***Interactive comment on “Water balance modelling in a semi-arid environment with limited in-situ data: remote sensing coupled with satellite gravimetry, Lake Manyara, East African Rift, Tanzania” by D. Deus et al.***

General reply to Reviewer 1-C4854-2011

Figure 1: Model result based on (a) MODIS LST and (b) in-situ air temperature

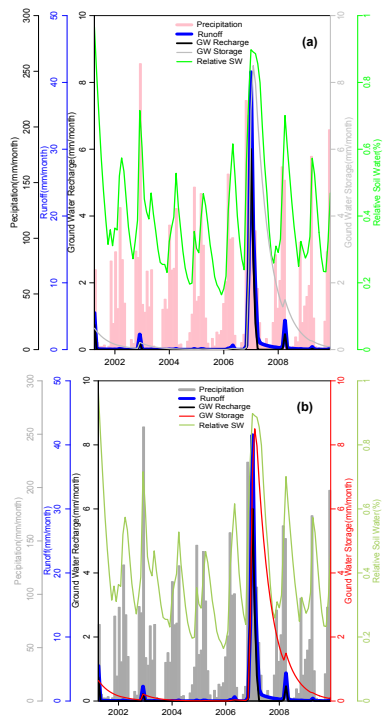
As it is explained in the paper, MODIS LST product is used as model input. This means that evapotranspiration is also calculated using LST data. However, the Penman-Montheith method for ET estimation uses air temperature as an input. This is why the authors should clarify how LST was integrated into the model. Was it directly used constituting air temperature information, which is actually not correct?

We agree that Penman\_Montheith method for ET estimation use air temperature as input. Nonetheless we showed that LST and air temperature are correlated and therefore we can estimate air temperature from LST. In order to check the effect of using LST we used both air temperature and MODIS LST to force two separate models. The results produced using MODIS LST and in-situ air temperature are very similar and we conclude that air temperature estimated from LST is a valid temperature input (Fig. 1a,b). We have edited the text to make these points clearer.
